SR 520 Bridge Replacement and HOV Program

To: Lynn Peterson, Washington Transportation Secretary
From: Julie Meredith, SR 520 Program Director
CC: Cam Gilmour, WSDOT Chief Operating Officer
Keith Metcalf, WSDOT Chief Engineer
Jeff Carpenter, WSDOT State Construction Engineer
Date: July 30, 2013
Re: SR 520 Program and Change Order Update

SUBJECT: Contract 008066
SR 520, Floating Bridge and Landings Project
Federal Aid No. BR-0520(047)
Change Order No. 108 – PFS Cycle 1 Repair

Description:
This is a WSDOT-Initiated Change in accordance with General Provisions Section 1-04.4(1). This change order addresses the addition of Work to repair cycle 1 Pontoons Furnished by the State (PFS), Pontoons T, U, V and W, to achieve the required Design Life of 75 years.

PONTOON 'T' BLOCKING LAYOUT

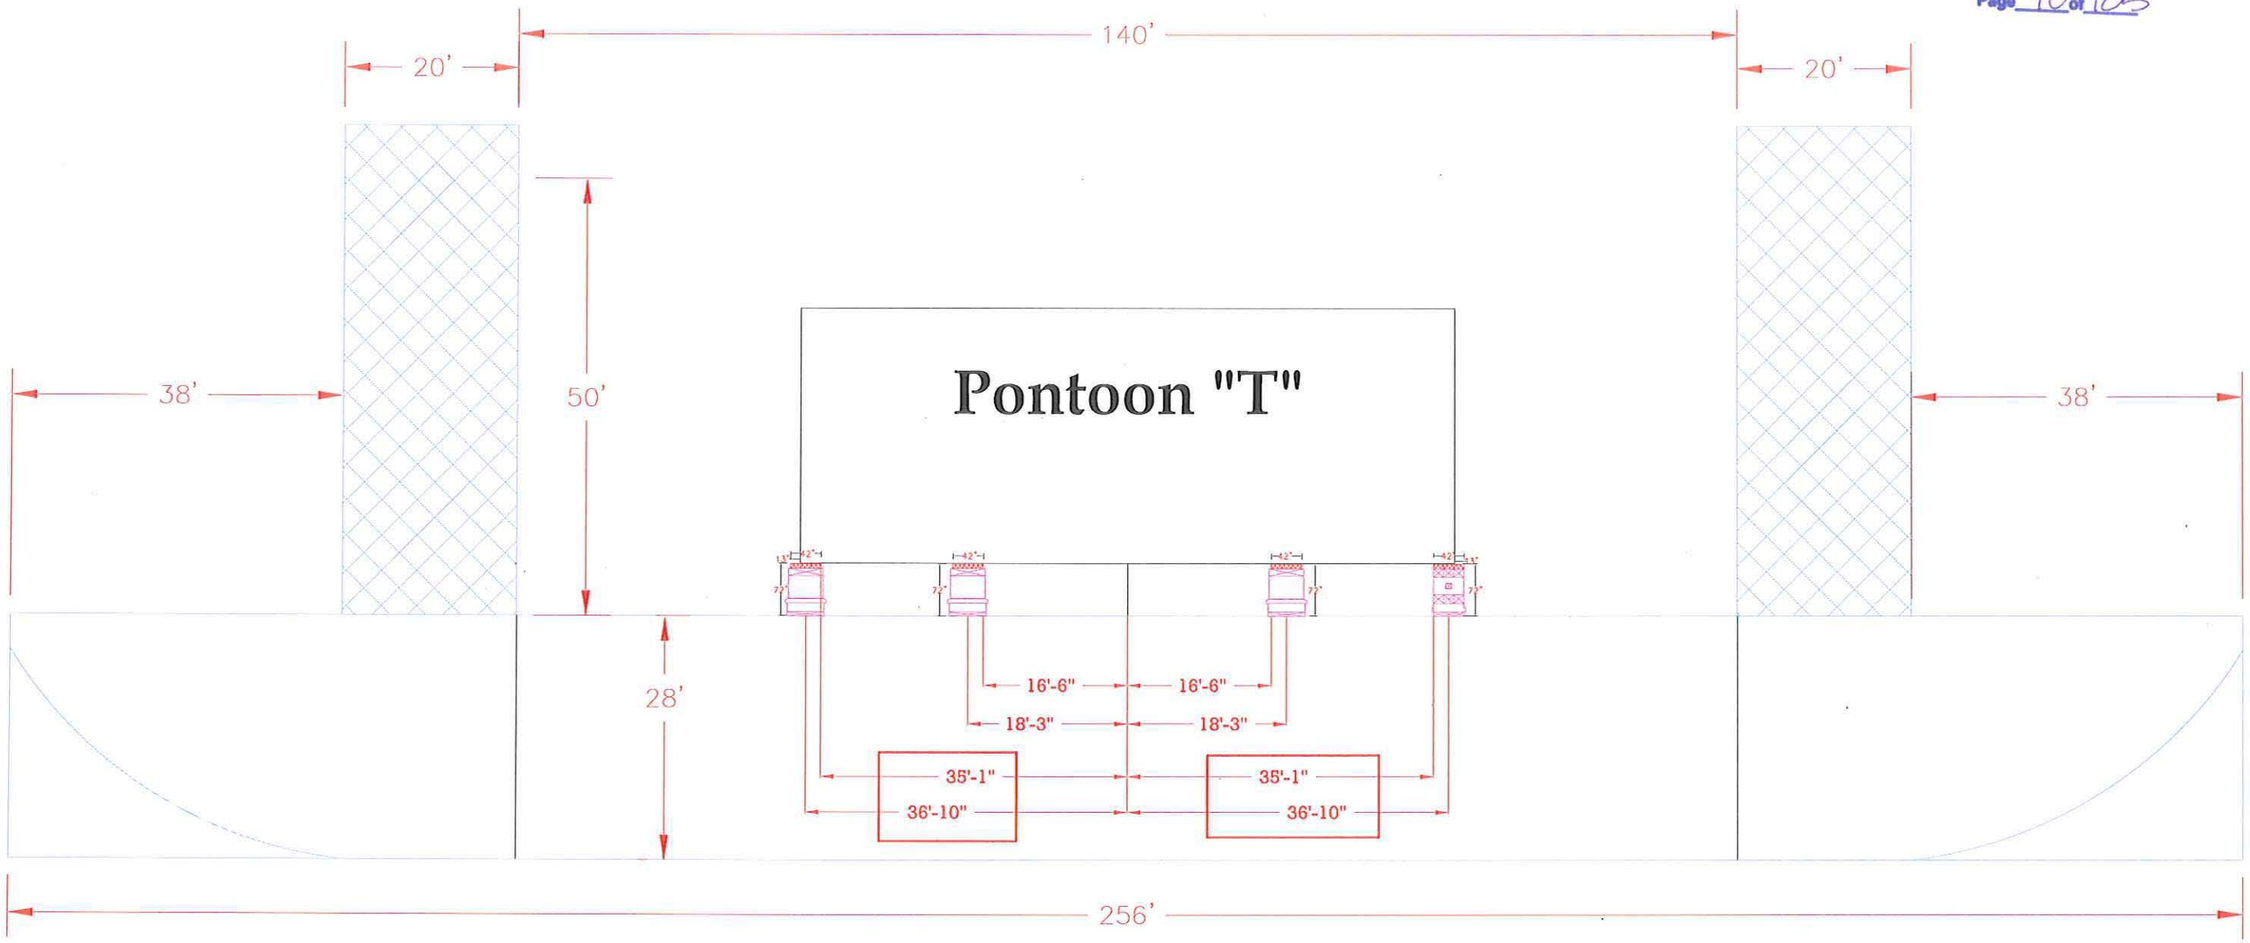
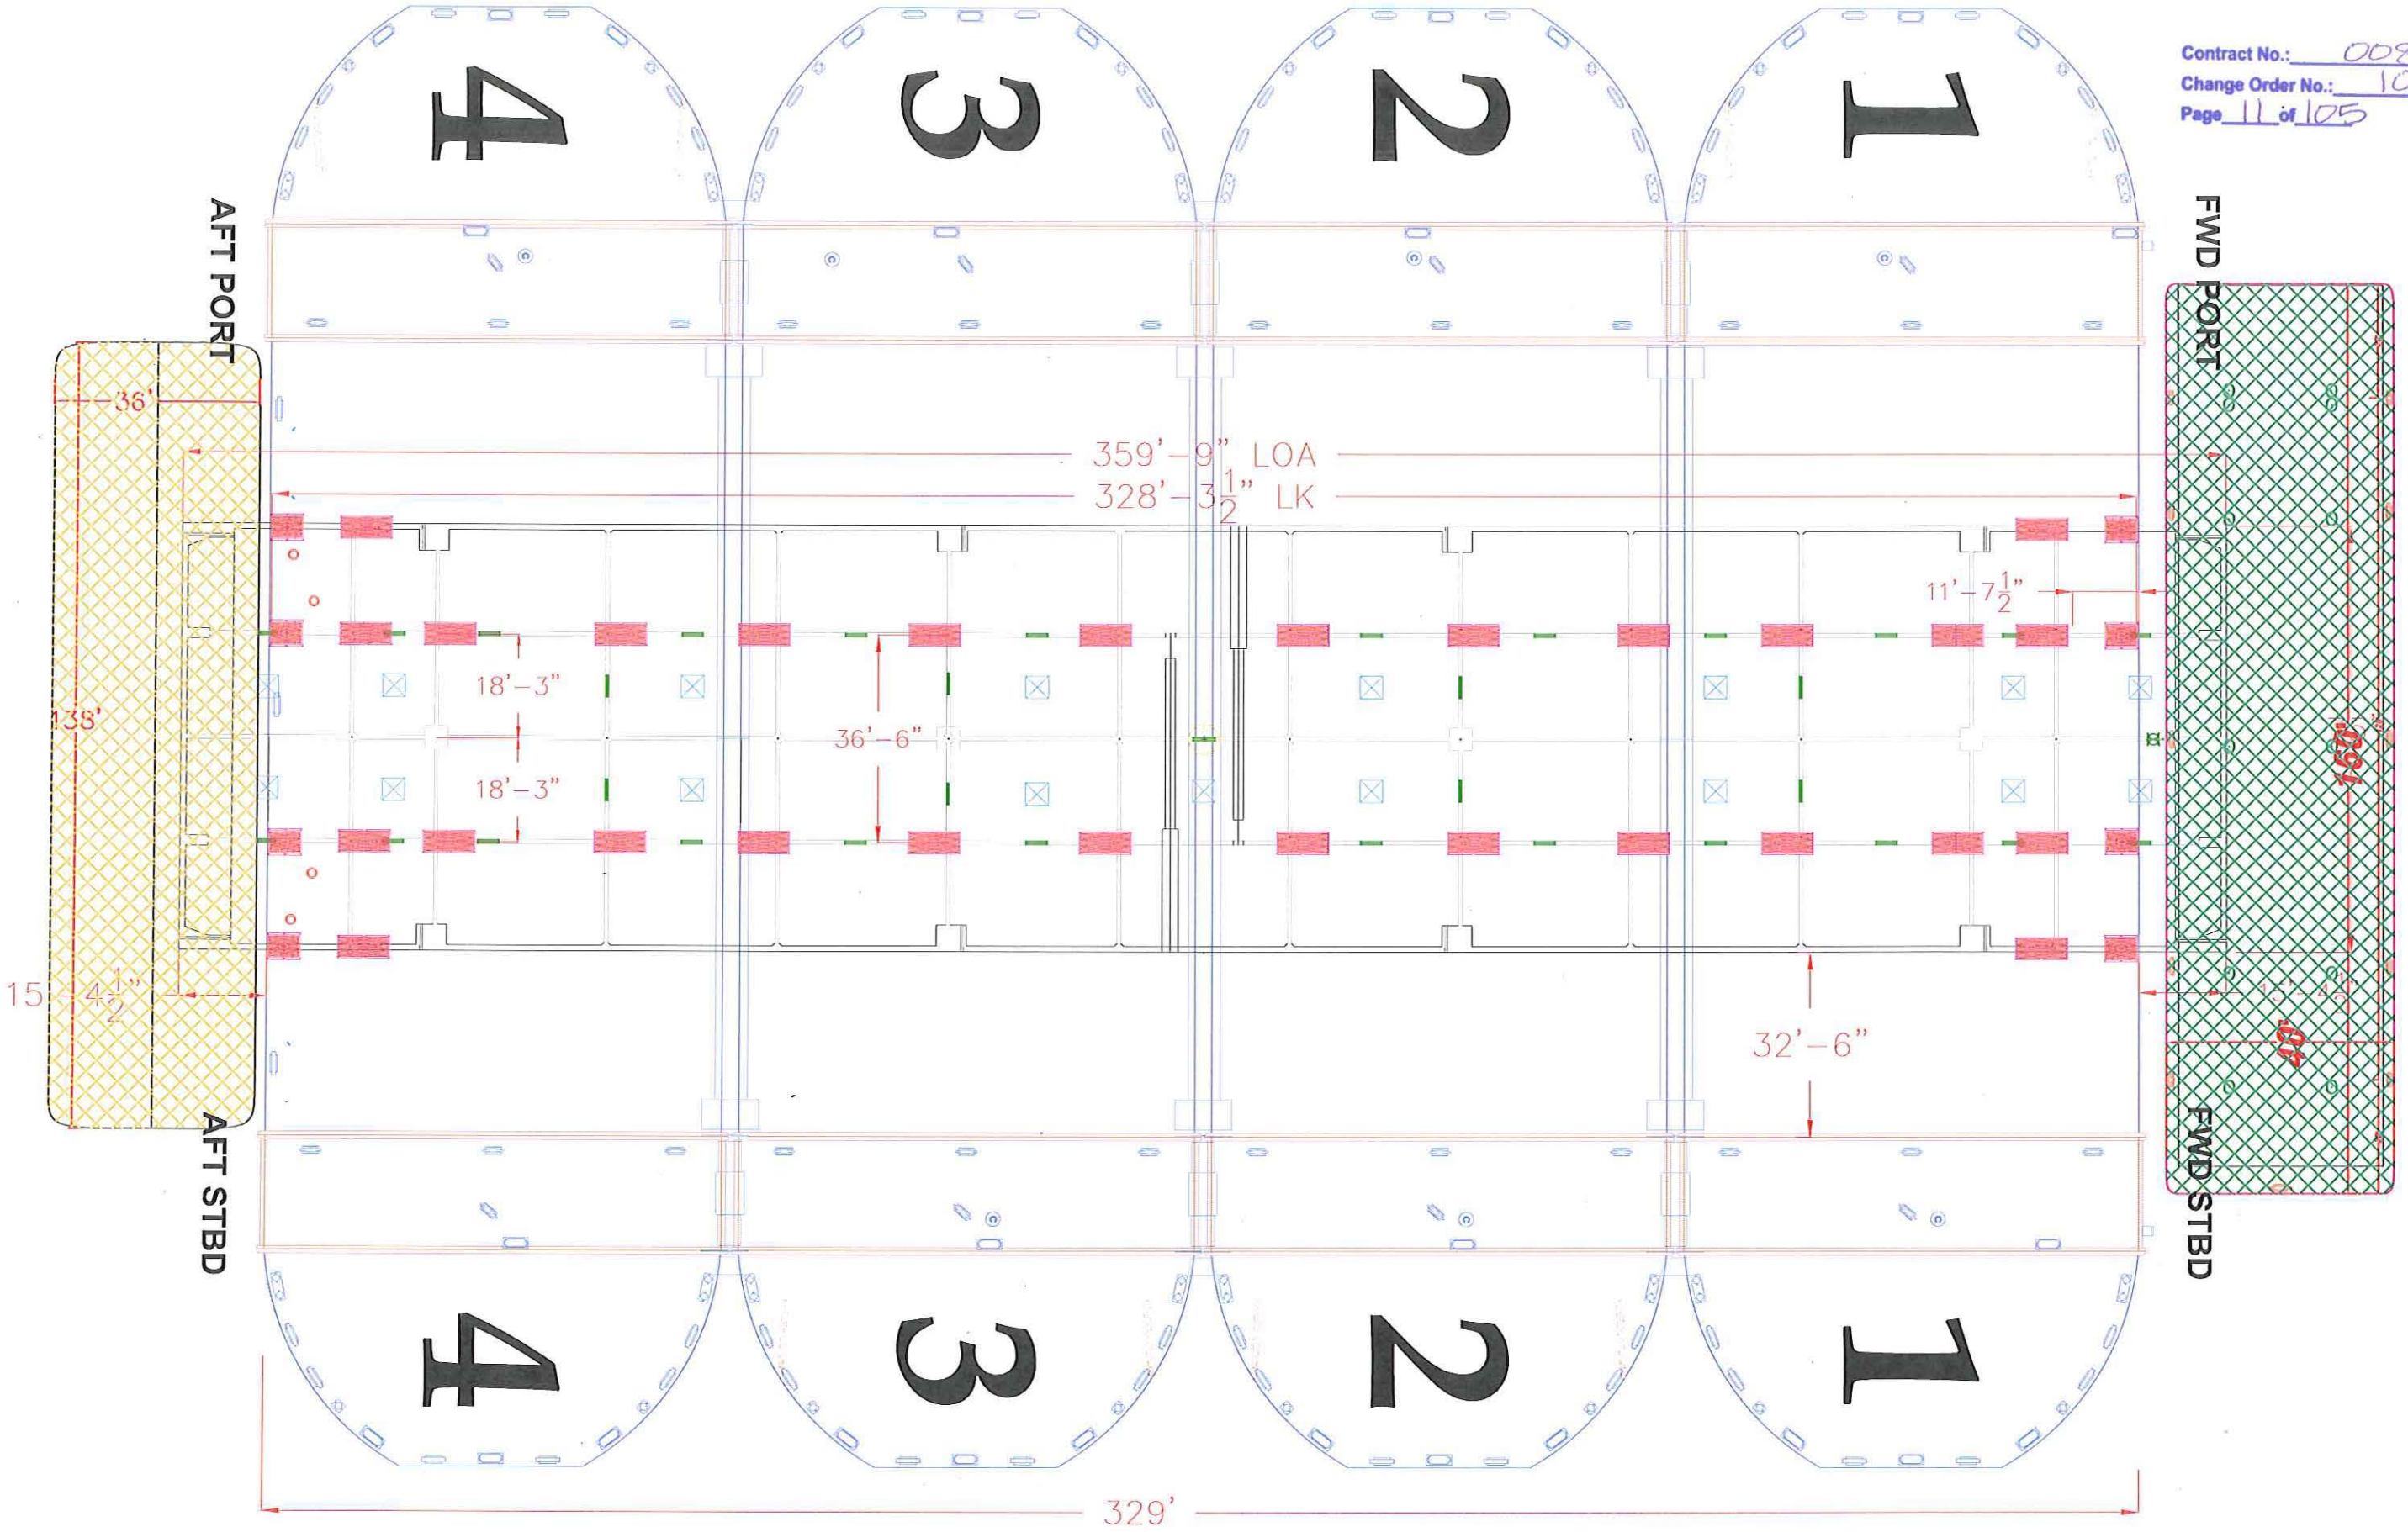
Construction Requirements:
The Design-Builder shall tow Pontoon T to the Vigor Industrial dry docking facility shipyard in Portland, OR and Pontoon W to Vigor's shipyard in Seattle, WA. The dry docking facilities shall be utilized to perform repairs to Pontoons T and W, and other Work as specified in this change order. Pontoons T and W shall be towed back to Lake Washington upon completion of the Work.

PONTOON W BLOCKING LAYOUT

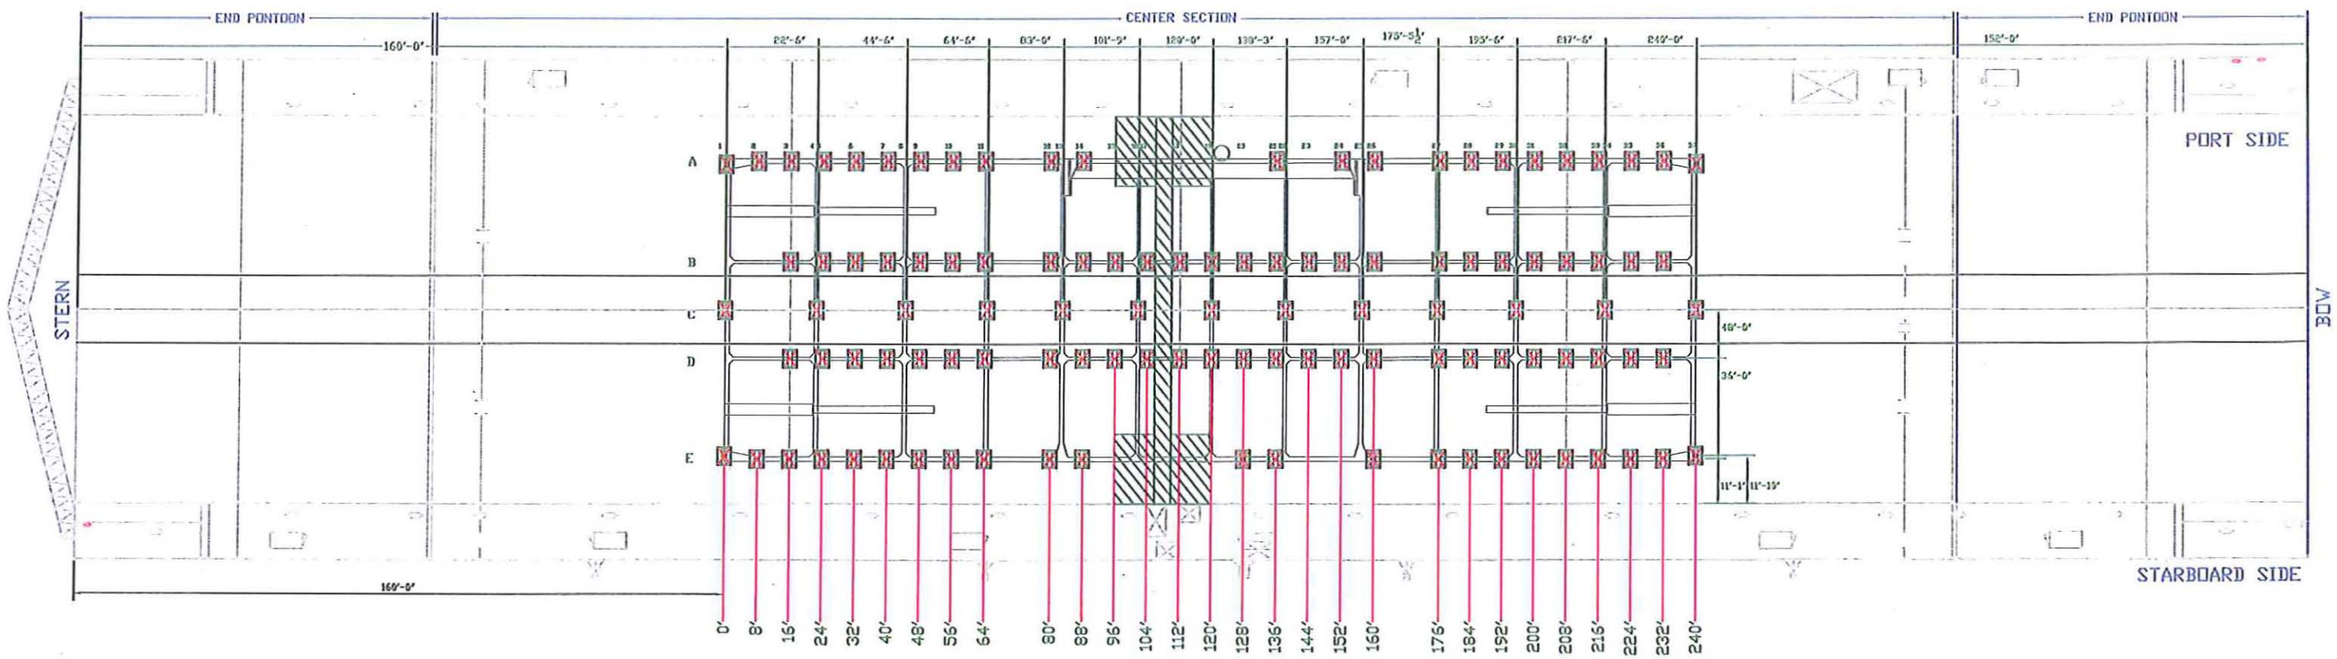
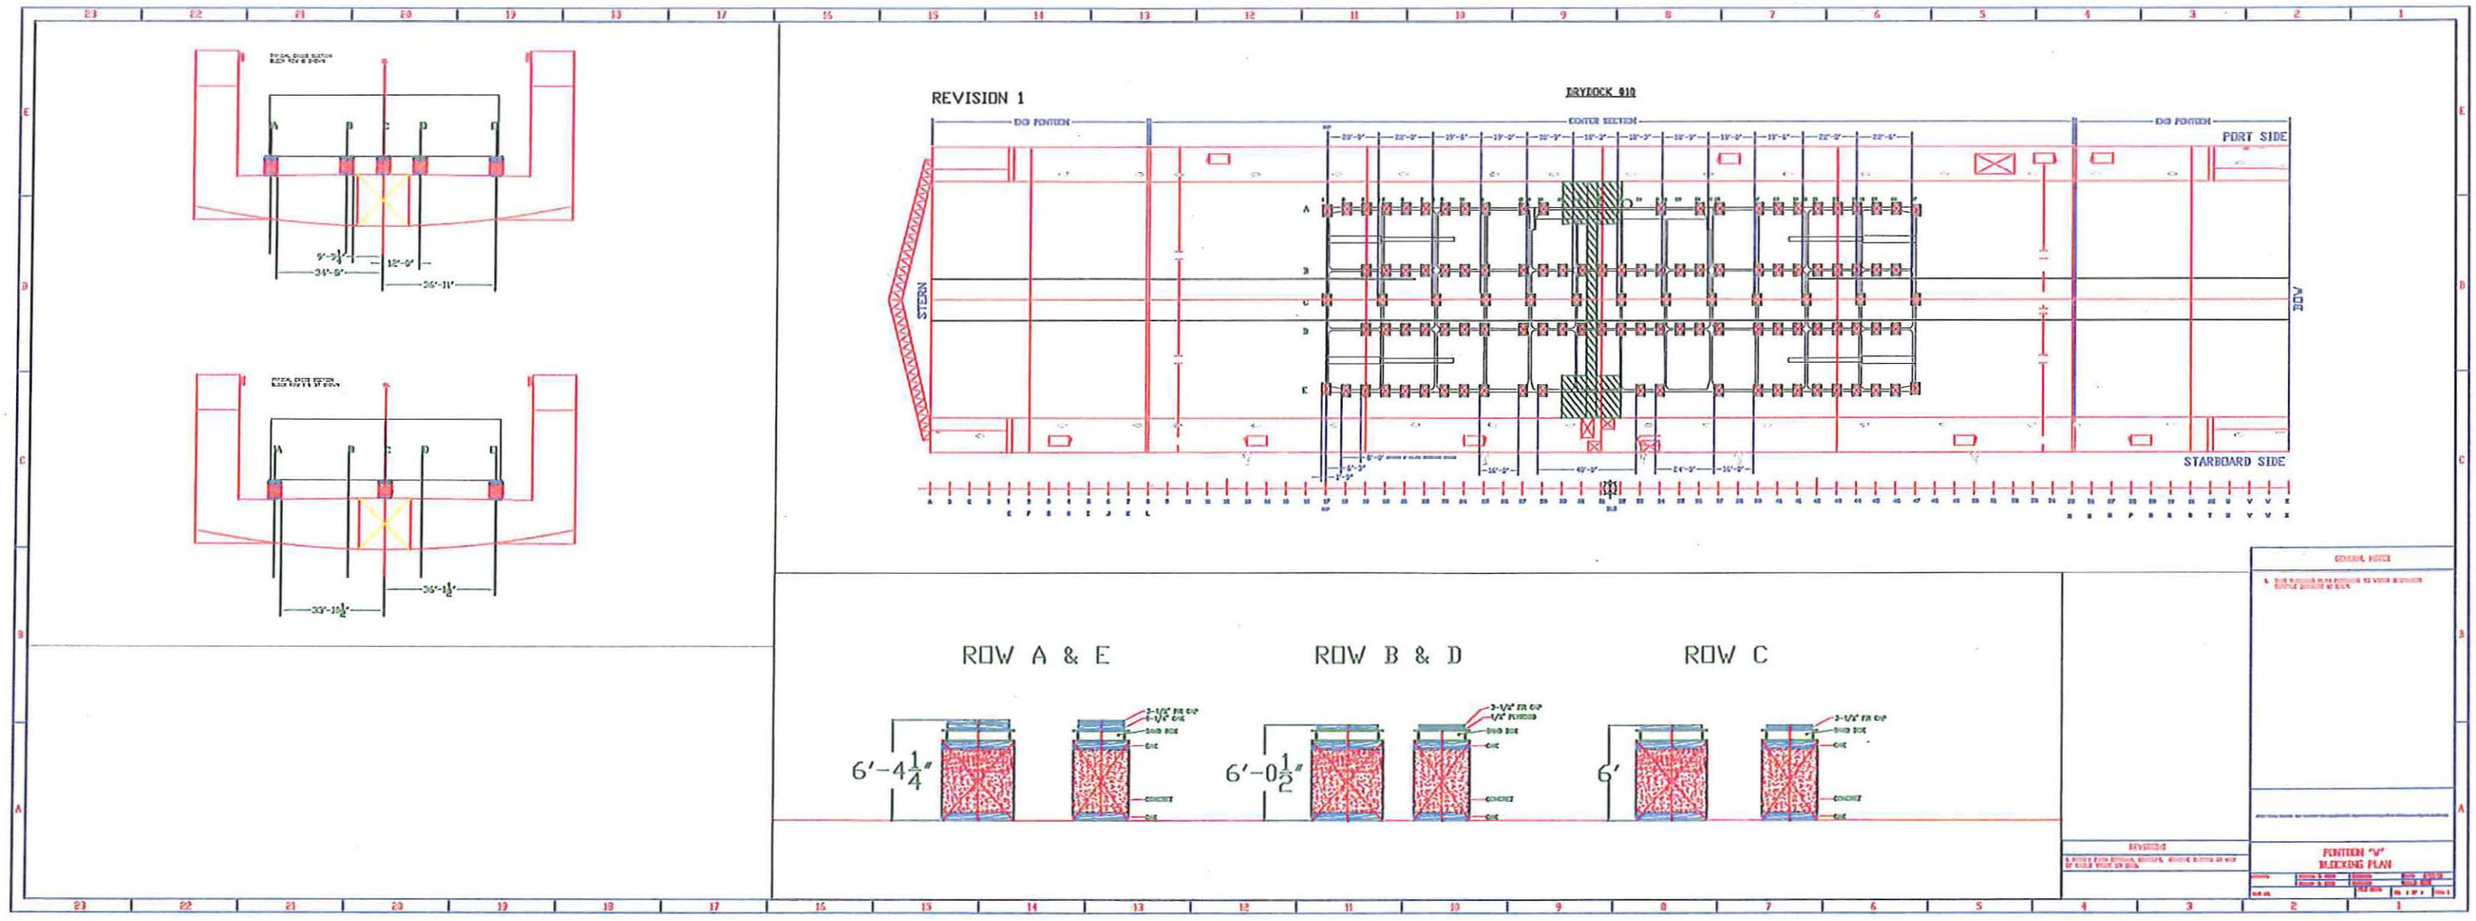
The Design-Builder is responsible for determining, with WSDOT's concurrence, whether the transport of Pontoon W through the Montlake Cut requires the removal of the structural elements constructed above the Pontoon deck. If the removal of the structural elements is determined to be necessary, the elements shall be removed in order to provide the appropriate buoyancy for Pontoon W to pass undamaged through the Montlake Cut, and shall be reconstructed once Pontoon W is returned to Lake Washington.
